KISSIMMEE RIVER RESTORATION STUDY

COMMUNICATION

THE ASSISTANT SECRETARY OF THE ARMY
(CIVIL WORKS)

A LETTER FROM THE CHIEF OF ENGINEERS, DEPARTMENT OF THE ARMY DATED MARCH 17, 1992, SUBMITTING A REPORT TOGETHER WITH ACCOMPANYING PAPERS AND ILLUSTRATIONS, PURSUANT TO SECTION 116(h) OF THE WATER RESOURCES DEVELOPMENT ACT OF 1990

FIGURE 9

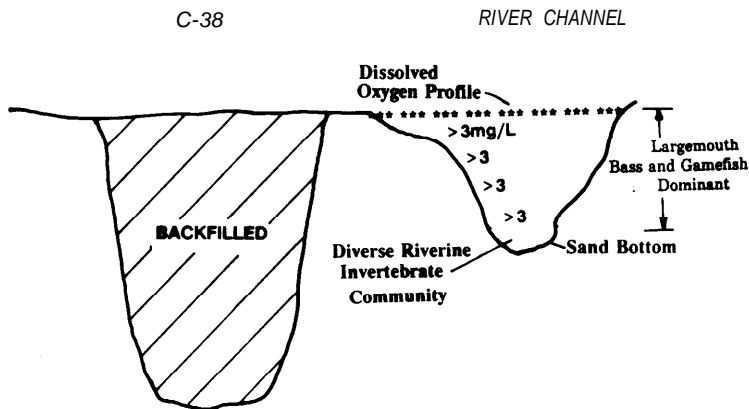
Figure 9, page 37, is a misrepresentation of the vertical stratification of rough and game fish species within the C-38 and remnant river figure attempts to present a distributional relationship between stratification of dissolved oxygen levels, and the dissolved oxygen requirements of game and rough fish species. Under present conditions, rough fish species are concentrated within the upper few feet of the water column and bowfin are capable of withstanding depressed dissolved oxygen concentrations similar to levels found in the deeper waters of the river; however, this should not be construed as to indicate where these species are usually located within the water column. In fact, game and bowfin are usually located near the surface as this is where their prey items are concentrated.

Figure 9 is adequate for the graphic presentation of the vertical stratification of dissolved oxygen in the C-38 and remnant river channel. A separate line graph should be employed to present the oxygen requirements of fish species found in the Kissimmee River.

FIGURE 18

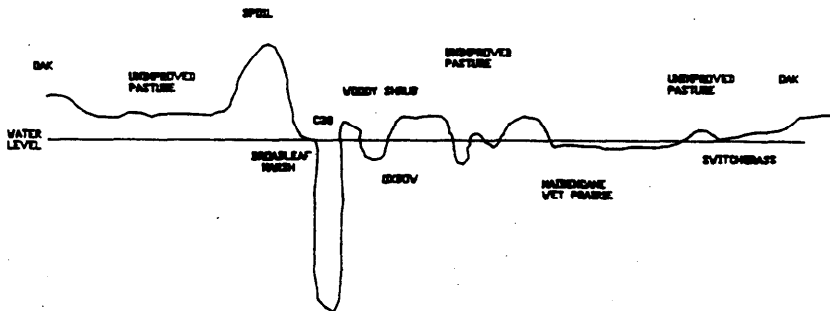
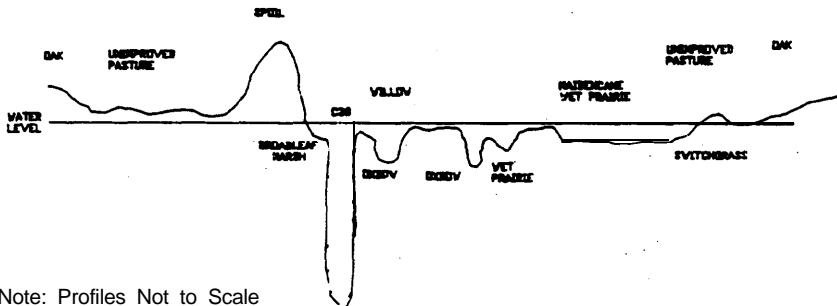
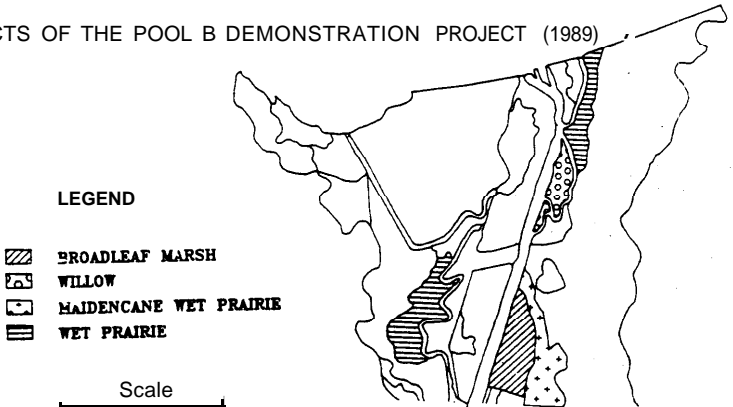
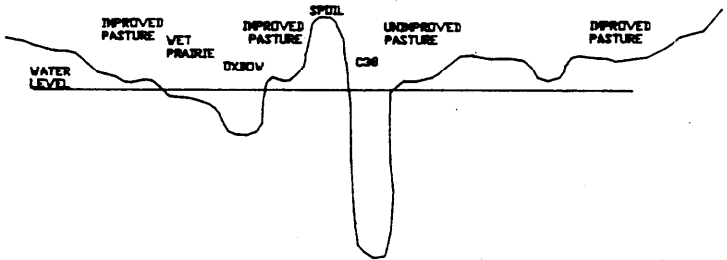
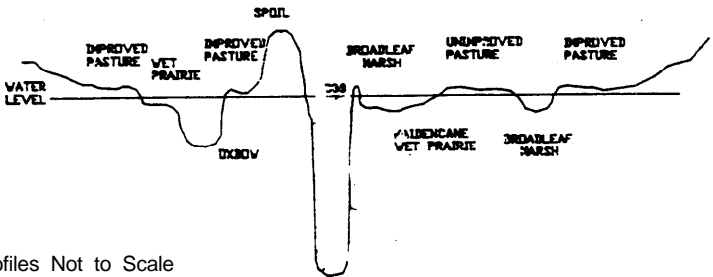
Finally, Figures 18 and 20 need to have a Y-axis and identification of the flow. This would clarify the effect of channelization and altered flow regime.

Comment: Figures 18 and 20 need to have Y-axis and identification of the flow.

Response: Figures 18 and 20 are graphic cross section views that show a profile, or "slice," of the Kissimmee River ecosystem in the central and northern areas of Pool B. Vertical (Y-axis) differences in the profile line display topographic differences across each section; the vertical differences are not to scale.
